Office Action Summary

09/531,735

LEVIN ET AL.

DETAILED ACTION

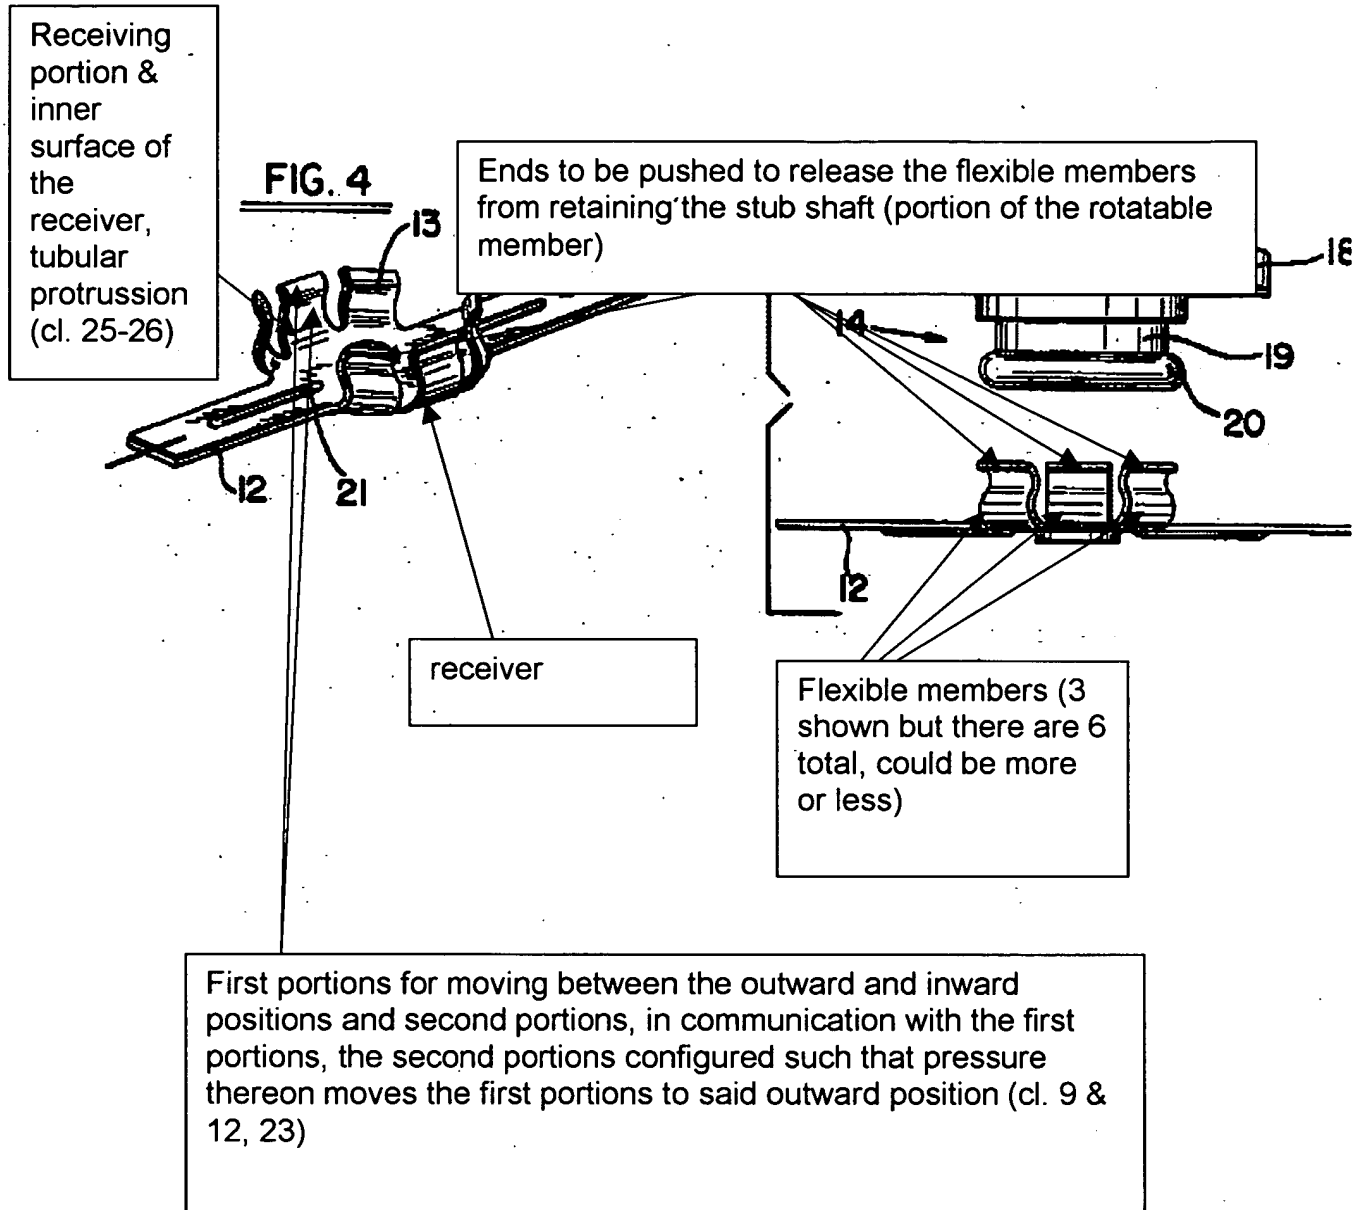
In re independent claims 9 & 12 & 16 & 19, 23, Weber discloses as also shown in the marked up figures below, a lawnmower blade assembly comprising:

a shaft (15) configured to be rotatable with a motor (10);

a stub (19, 20) in communication with the shaft (fig 2);

a blade (12);

a receiver (22) coupled to the blade (fig 4, 5), the receiver including a receiving portion (13) and at least a plurality of flexible members (13) configured for moving between outward and inward positions for engaging and retaining the stub in the receiving portion (fig 2) in a releasable engagement, the flexible members ends configured such that pressure thereon moves the flexible members outward, allowing for at least the disengagement of the blade from the stub (as the top ends of flexible members of the receiving portion is moved outwardly the receiver is released from the stub shaft);

a stub (19, 20) in communication with the shaft (fig 2);

a blade body (12) including oppositely disposed cutting portions (fig 6, blade 12 having oppositely disposed cutting portions) and a platform intermediate the cutting portions (as best shown on fig 4, the receiver is placed between the oppositely disposed cutting portions or in the middle of ref 12);

a receiver (22) coupled coaxially to the blade (fig 4, 5), the receiver including a receiving portion (13) and at least a plurality of flexible members (13) configured for moving between outward and inward positions for engaging and retaining the stub in the receiving portion (fig 2) in a releasable engagement, the flexible members including ends configured such that pressure thereon moves the flexible members outward, allowing for at least the disengagement of the blade from the stub (as the top ends of flexible members of the receiving portion is moved outwardly the receiver is released from the stub shaft);

in re claims 13 & 17 & 20, 24, the flexible members (or spring clips 13) are spring like (i.e. can be pushed outwardly to disengage the stub shaft and when released it will press against the stub shaft; col. 2, line 18).
